WENTWORTHVILLE PUBLIC SCHOOL

State Design Review Panel – Response to Advice Schedule

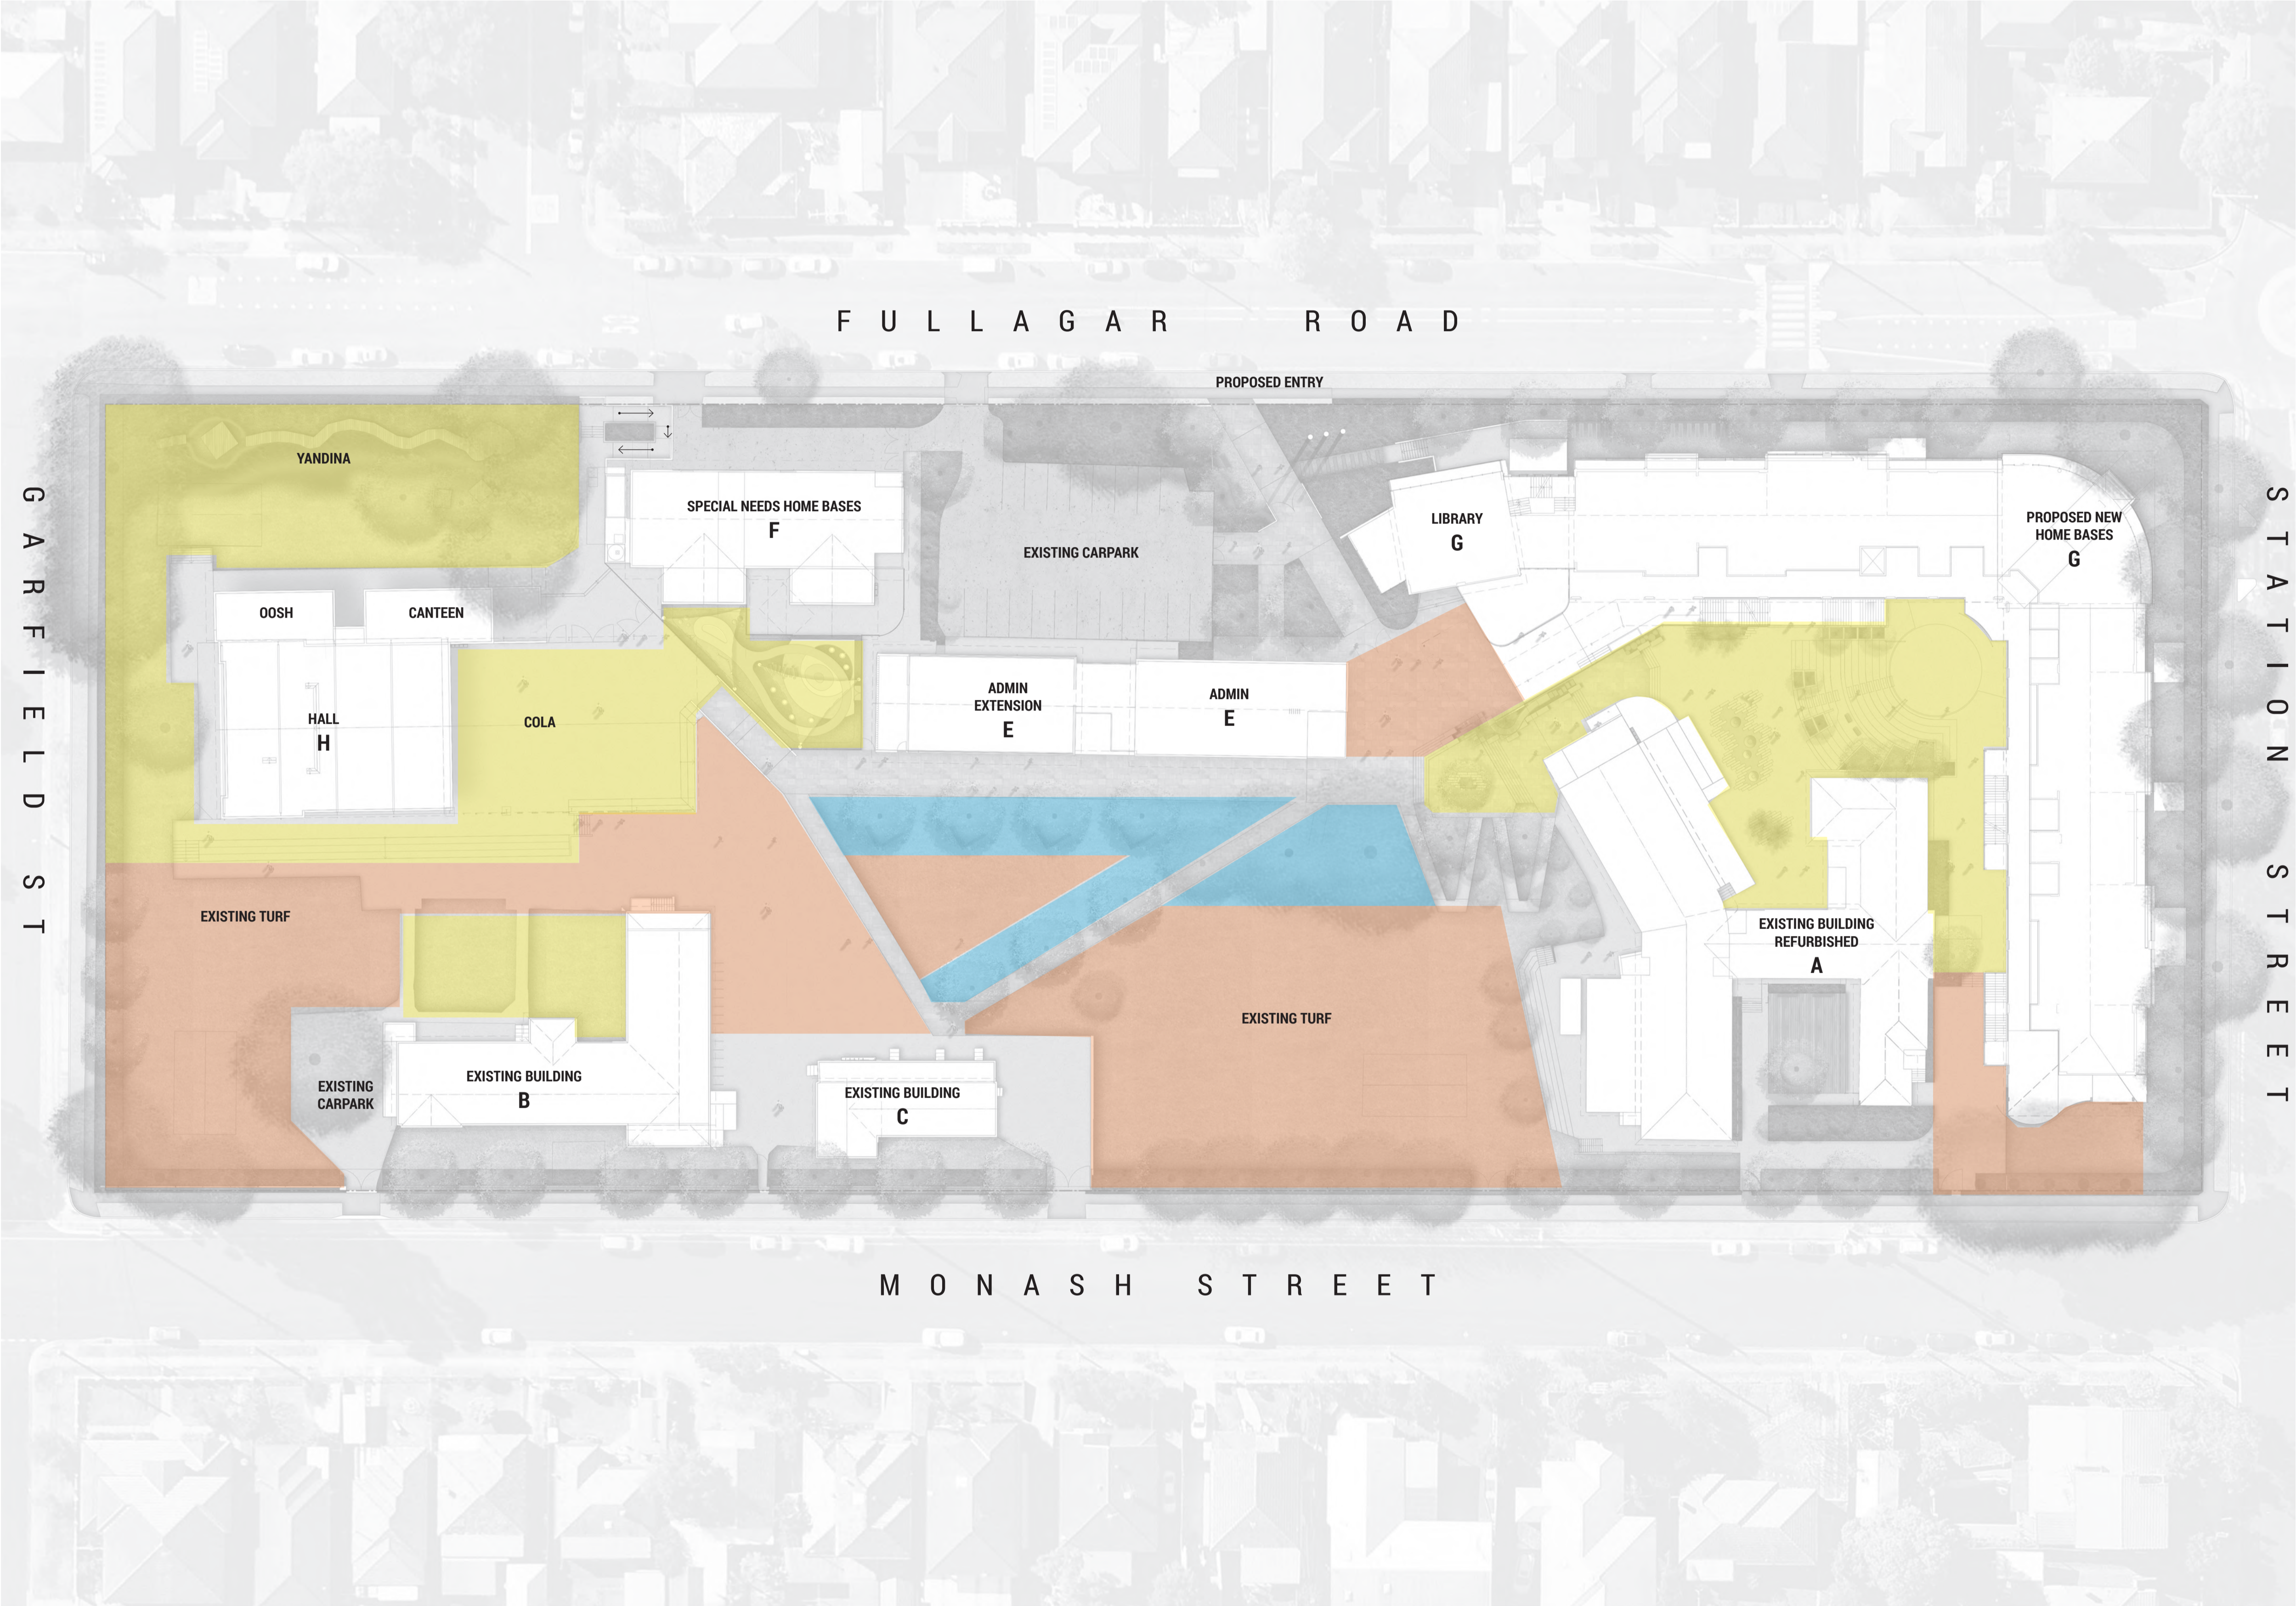
4 – School Entries		
4a	<p>The Panel recommends:</p> <p>a single entry at Monash St, to maximise the opportunity for soft landscaping and provide a more readily recognisable entry (between existing buildings) with a clear, direct connection to the covered open learning space (COLA).</p>	<p>Refer to comment in Item 1e above. Given this we believe that all the proposed gates are necessary in accordance with the requirements of the Department of Education.</p>
	<p>consideration of the orientation and façade treatment of the Library at Fullagar Rd, to provide greater distinction from the remainder of Block G. This will promote the sense of arrival and the Library's entry marker qualities</p>	<p>The Panel's comments regarding the re-orientation of the "cranked" Library element at the west end of Block G have been considered. The design intention is to form a transition between the Fullagar Road façade and the angled entry. Cranking the Library to 30 degrees (ie square with the entry path) would create a harsh disjointed connection. It would also have a negative impact on the function of the internal spaces of the Library. We believe the current angle to the Library element is appropriate and that the "pop out" section to the west provides the opportunity for school signage that helps create the school's entry marker element.</p>
